RE: PETITION NO. 1497A - Bloom Energy Corporation amended petition for a declaratory ruling, pursuant to Connecticut General Statutes §4-176 and §16-50k, for the proposed construction, maintenance and operation of a customer-side 2-megawatt fuel cell facility and associated equipment to be located at Bridgeport Hospital, 267 Grant Street, Bridgeport, Connecticut.

**Petition No. 1497A
Bloom Energy Corporation
Bridgeport Hospital
267 Grant Street, Bridgeport**

**Interrogatories – Set 2
June 21, 2023**

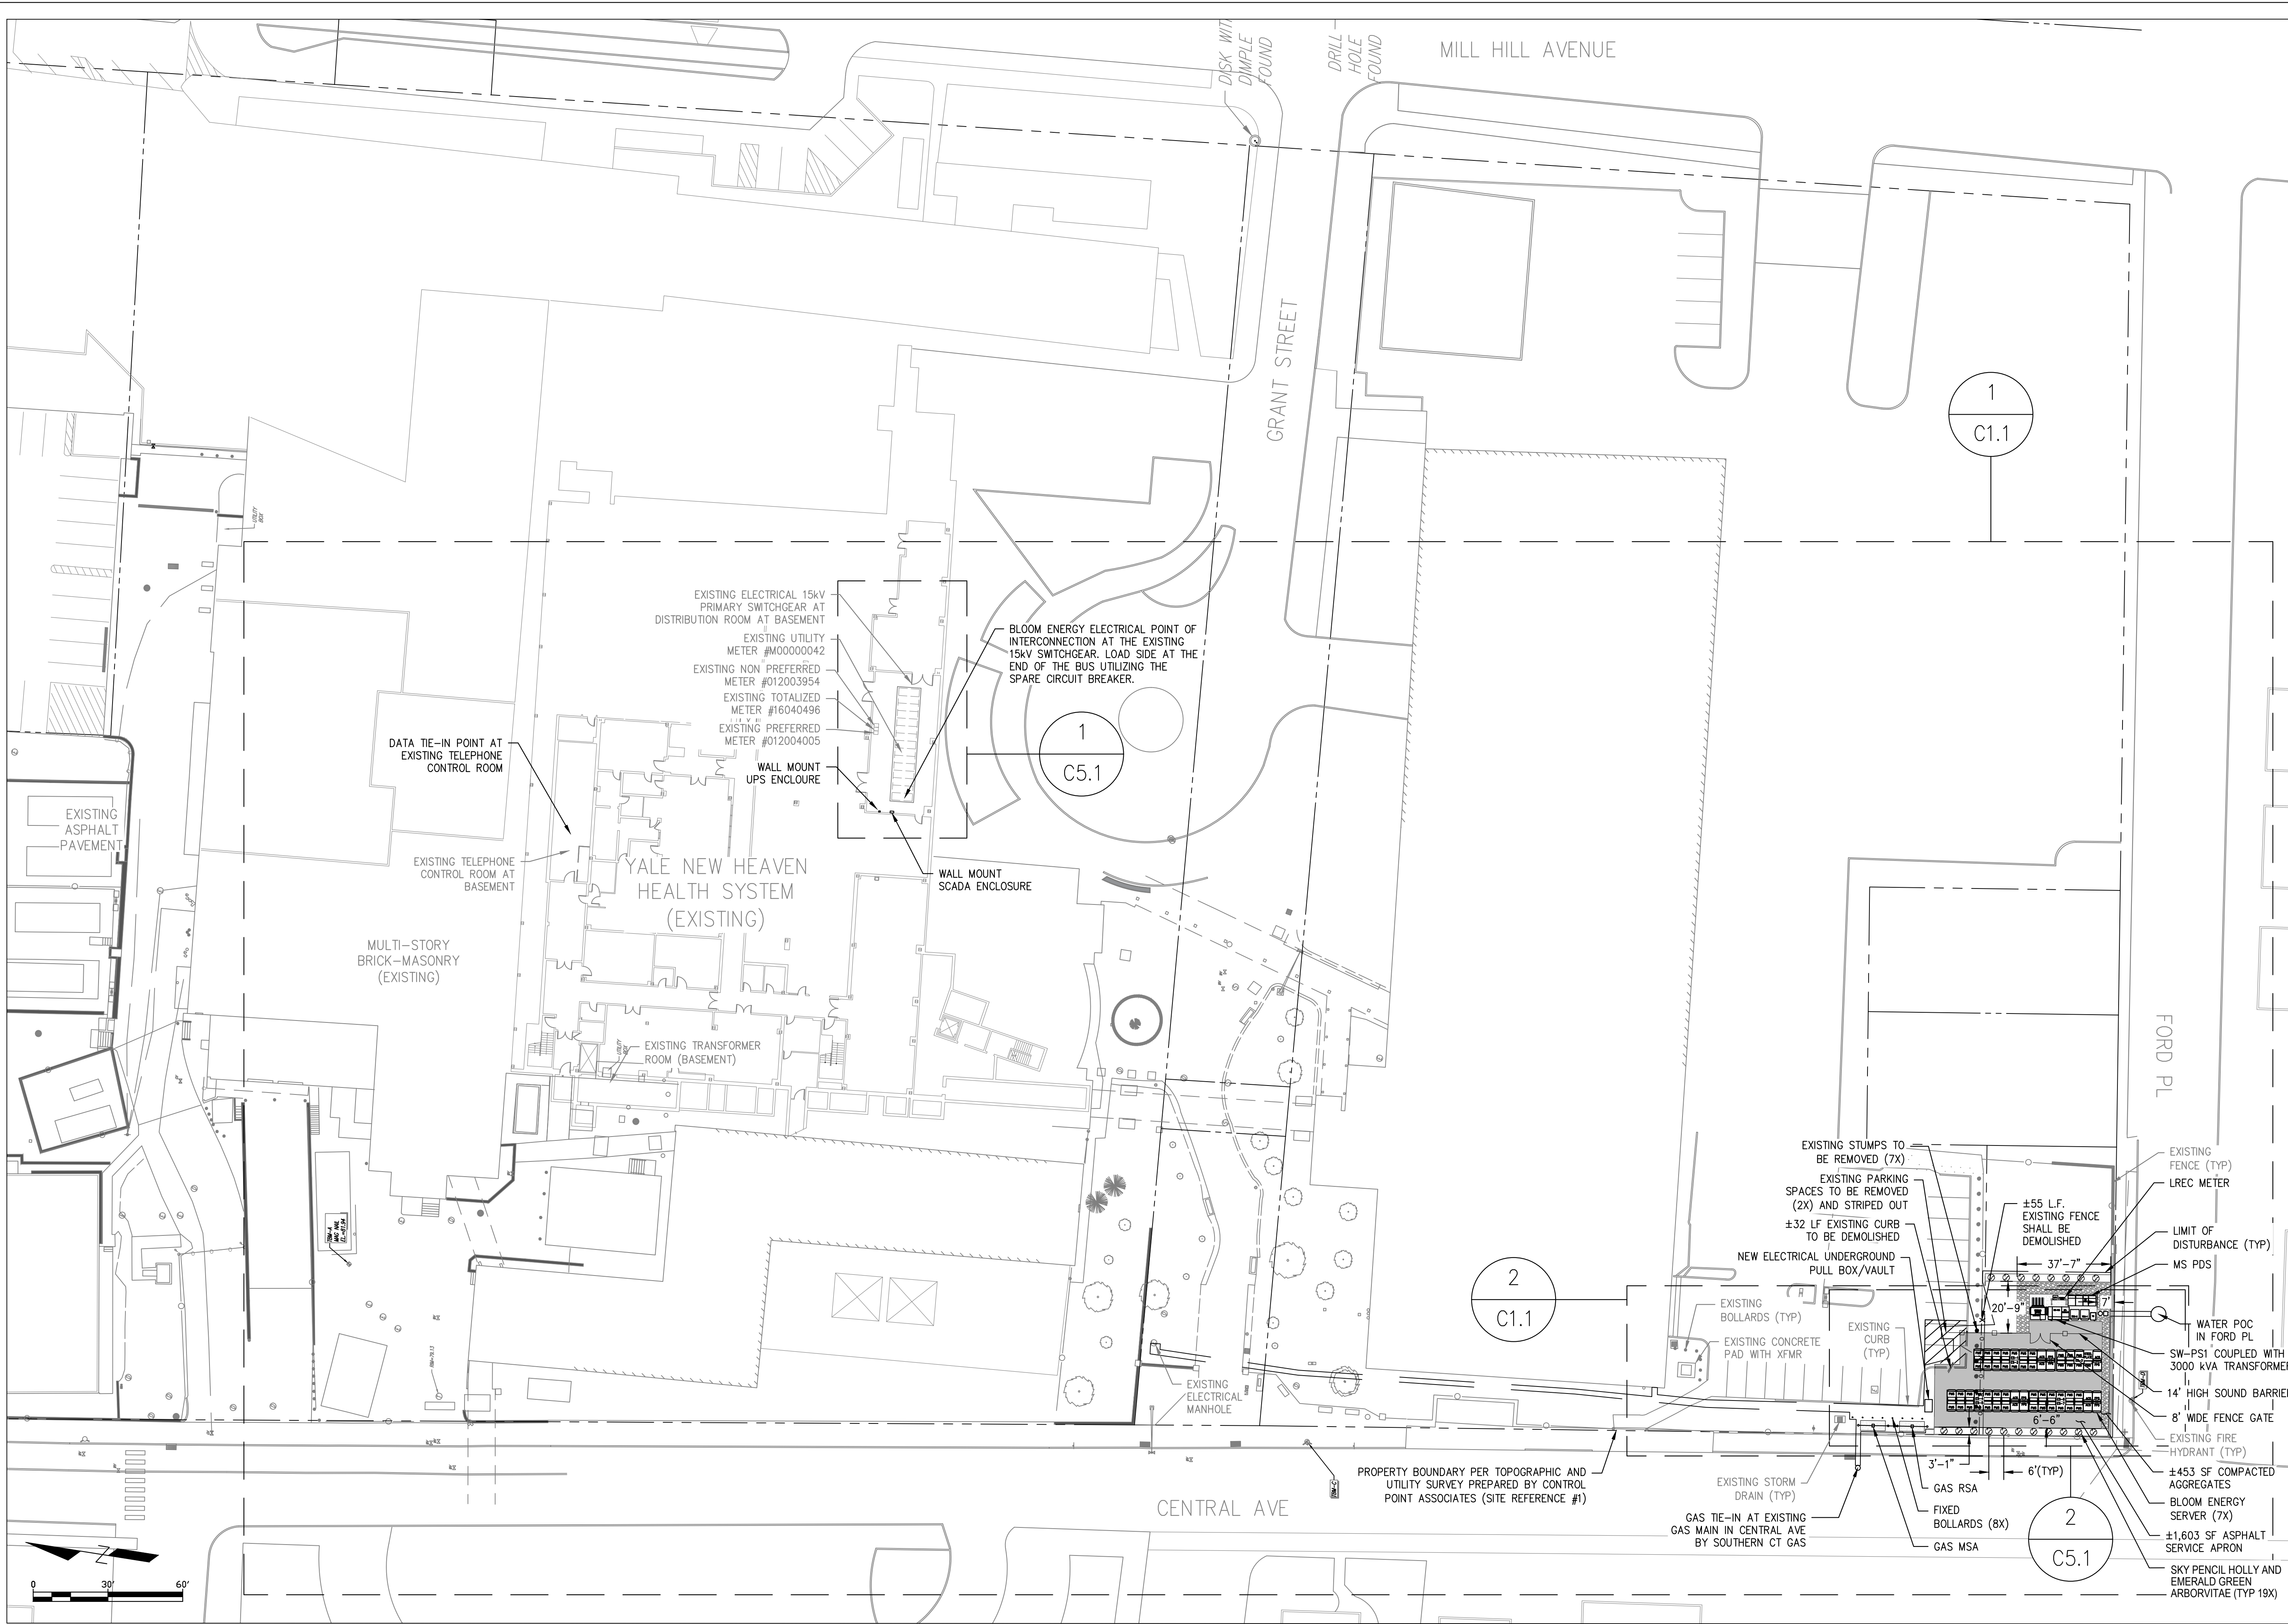
10. Referring to Response 8a, what color and/or alternate design options (ex. solid barrier design) are available that would match the surrounding area?

Response: The surrounding area consists of a variety of structures and a parking lot. The most prominent structure is the concrete parking garage located north of the proposed installation. The proposed cabinets are a neutral color that should blend with existing colors in use on sided or painted buildings. See Attachment B (existing fuel cell installations at Stamford Hospital and Milford Hospital). The manufacturer of the sound barrier material offers two colors: black and a "faux ivy" pattern. Bloom has not selected the faux ivy, which seems more suited visually to applications where the intent would be to mimic ivy growth on building façades. Please see Attachment C.

SHEET TITLE
UTILITY SITE PLAN

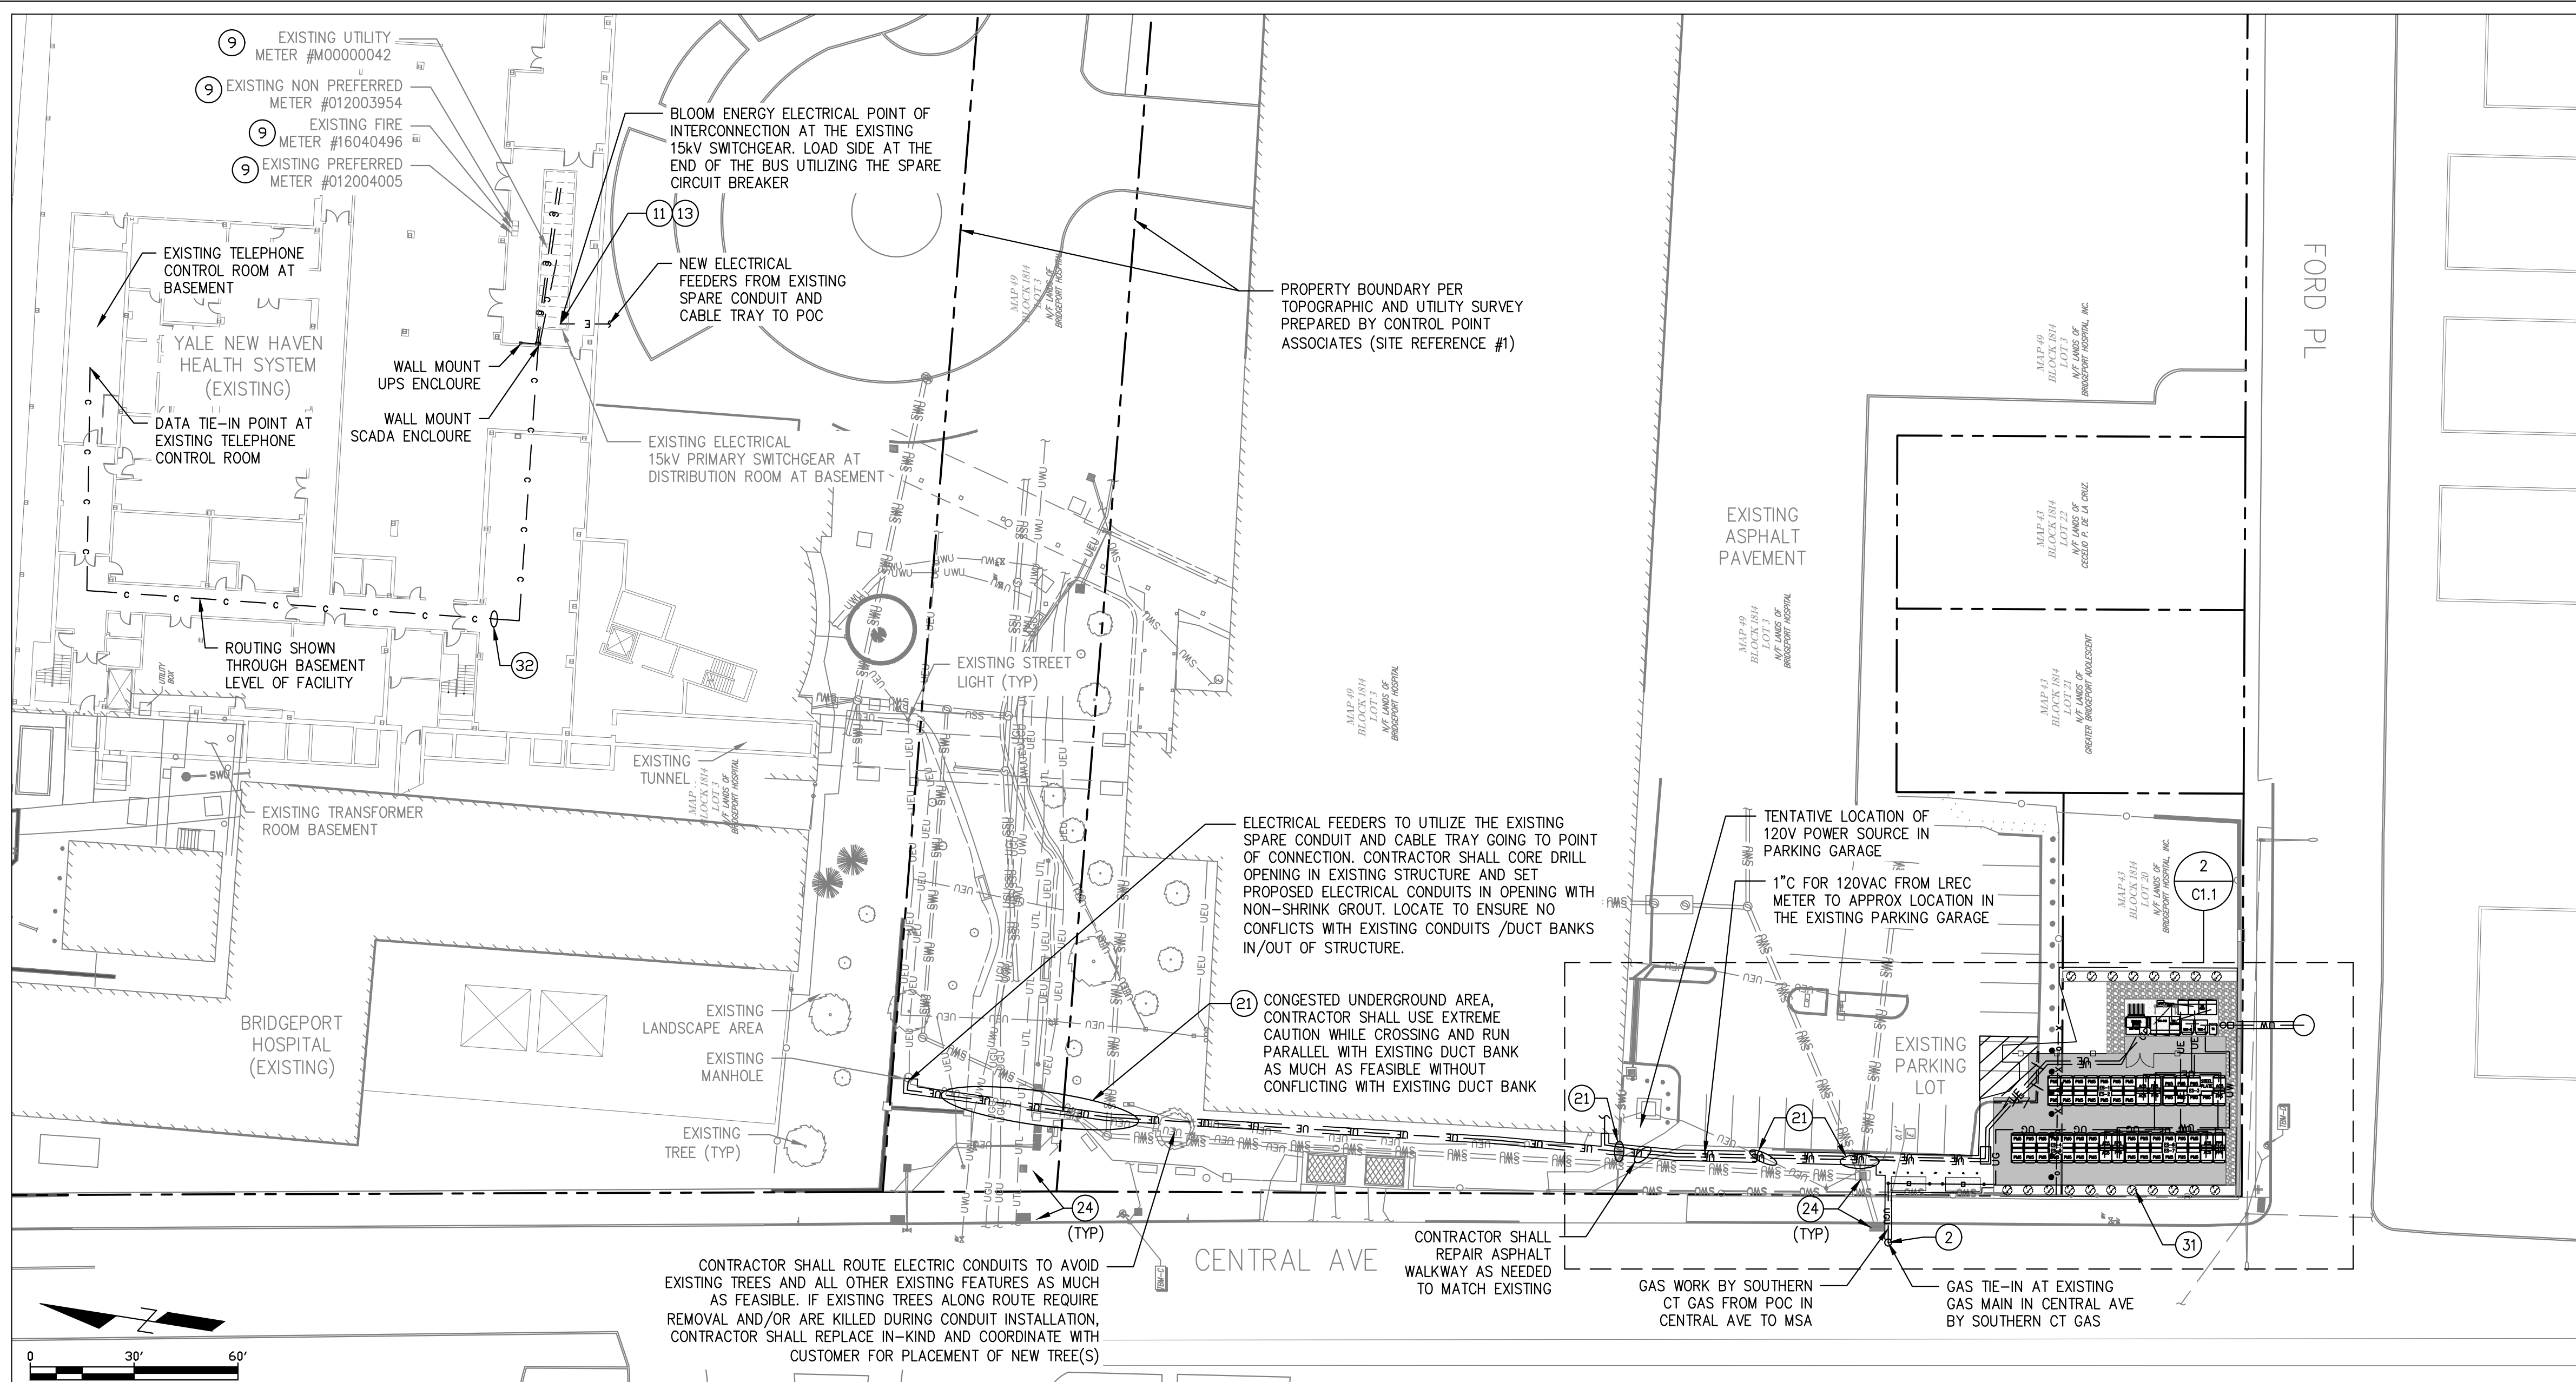
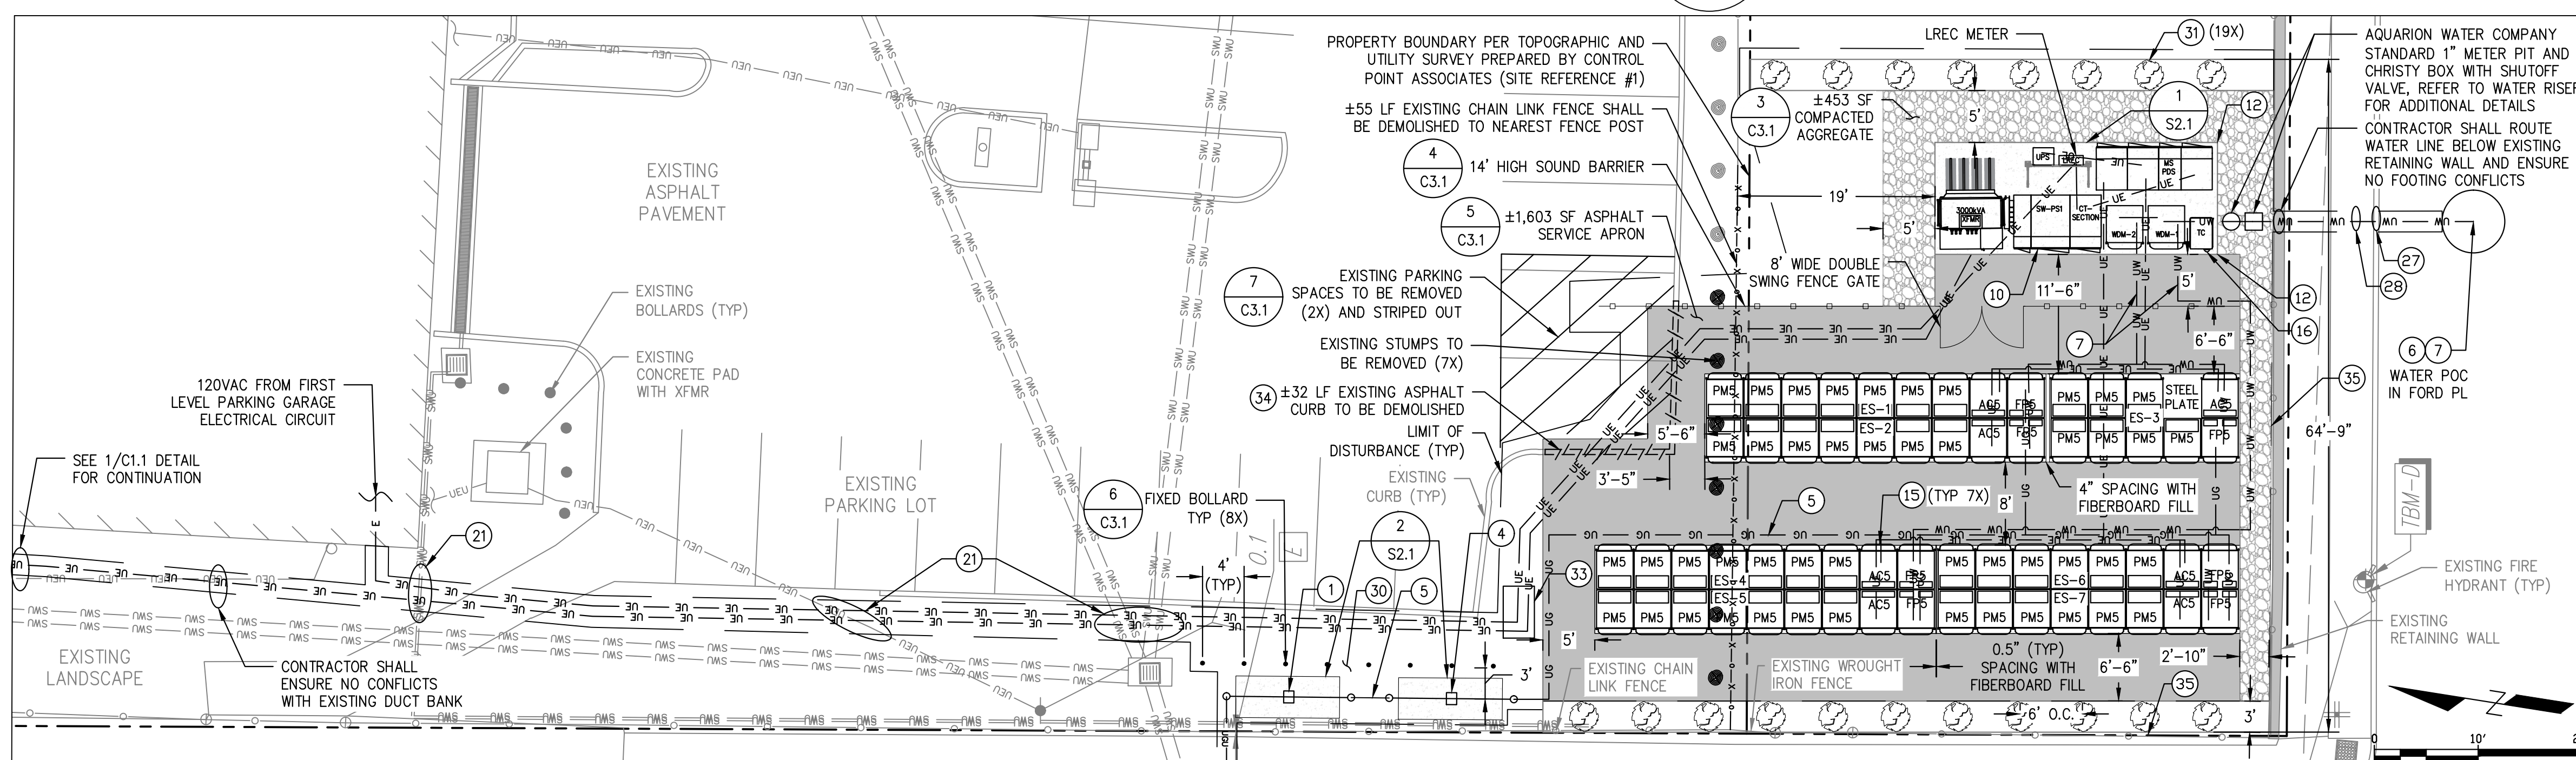
9. Referring to Interrogatory response 3, what potential visual mitigation measures could be incorporated into the project design consistent with the City of Bridgeport's urban design standards?

Response: Bloom has incorporated evergreen plantings at the east and west sides of the proposed installation. Because there is limited space between the existing fence and the fuel cell cabinets, Bloom has selected Sky Pencil hollies to provide visual interest and greenery and soften views of the Facility along Central Avenue, a major artery for both pedestrian and vehicular traffic. Arborvitaes will be installed between the proposed installation and the eastern property line. There is insufficient room along Ford Place to install plantings, and relocation to the north is not possible due to the need to minimize removal of additional parking spaces in the existing lot. Please see Attachment A for revised site plan.

- CONTRACTOR SHALL FURNISH AND INSTALL PROPOSED TREE. REFER TO PLANTING DETAIL FOR ADDITIONAL INFORMATION. WESTERN ROW OF TREES ALONG CENTRAL AVENUE SHALL BE SKY PENCIL HOLLY INSTALLED AT 6' O.C. SPACING, 5 GALLON CONTAINER (TYP 11X). EASTERN ROW OF TREES ADJACENT TO RESIDENTIAL PROPERTY SHALL BE EMERALD GREEN ARBORVITAE INSTALLED AT 6' O.C. SPACING, 4'-5' HEIGHT (TYP 8X).
